ADDENDUM No. 1

REQUEST FOR TENDER No.: 1220-020-2023-004

TITLE: DISTRICT ENERGY TRANSFER STATIONS AND
ASSOCIATED WORKS

ADDENDUM ISSUE DATE: AUGUST 17, 2023

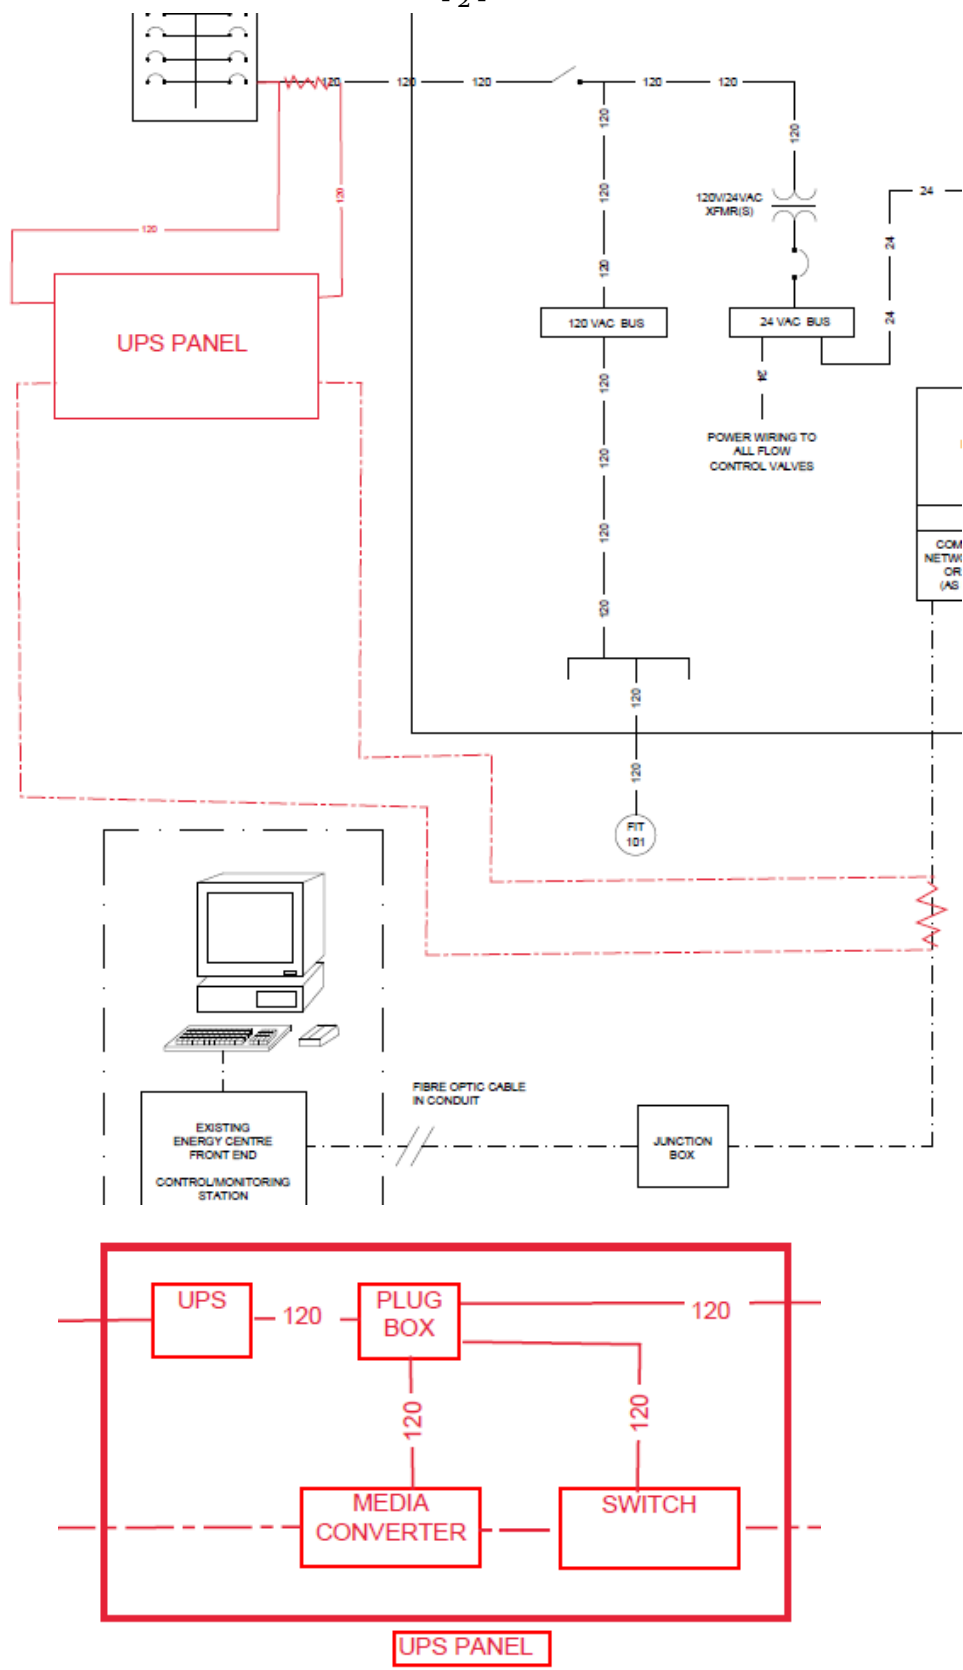
1. Add the following to Part F - Specifications (Project), in pdf. document - Surrey City Energy Specification Document Energy Transfer Station 2023-2024, Section 25 05 01 1.2.7:
 - .2 The bidder should allow for programming, devices, and commissioning to integrate the ETS controllers into the existing enteliWEB front end control system. As an alternative, integration of the ETS controllers into a new VT Scada front end control system is also acceptable.
2. In Part F - Specifications (Project), in pdf. document - Surrey City Energy Specification Document Energy Transfer Station 2023-2024, Section 25 05 01 2.5 Uninterruptible Power Supply (UPS) – Not Applicable; delete "Not Applicable."
3. Add UPS to each ETS. Refer to the snippets on the following page for control architecture of the UPS panels:
